REMARKS

Serial No. 10/615,818
Docket No. NEC 198130 DIV

Annotated Marked-up Figures 5B and 12B

Submitted with Amendment B

FIG. 5B

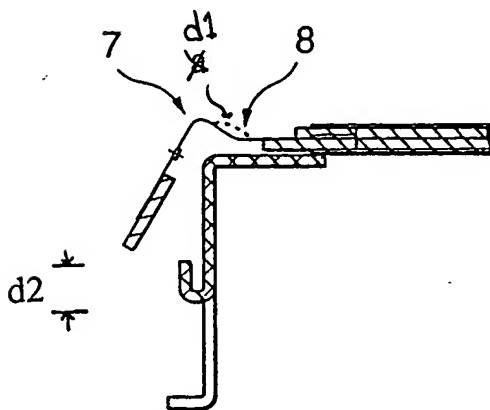
The drawing FIGS. 5B and 12B have been amended to include several reference characters.

Turning to the Examiner's objection as to the drawings, the claims, specification and FIGS. 5B and 12B have been amended accordingly. More specifically, main slit 7 and sub slit 8 are described as similar to the wide slit 10 (page 25, 4th paragraph). Also, FIG. 12B has been amended to label the main slit portion 100 and the sub slit portion 102, and to describe a distance d2 and d1, which is also depicted in amended FIG. 5B. Finally, claim 23 has been

Serial No.10/615,818
Docket No. NEC 198130 DIV
Annotated Marked FIG. 5B
Submitted with Amendment B
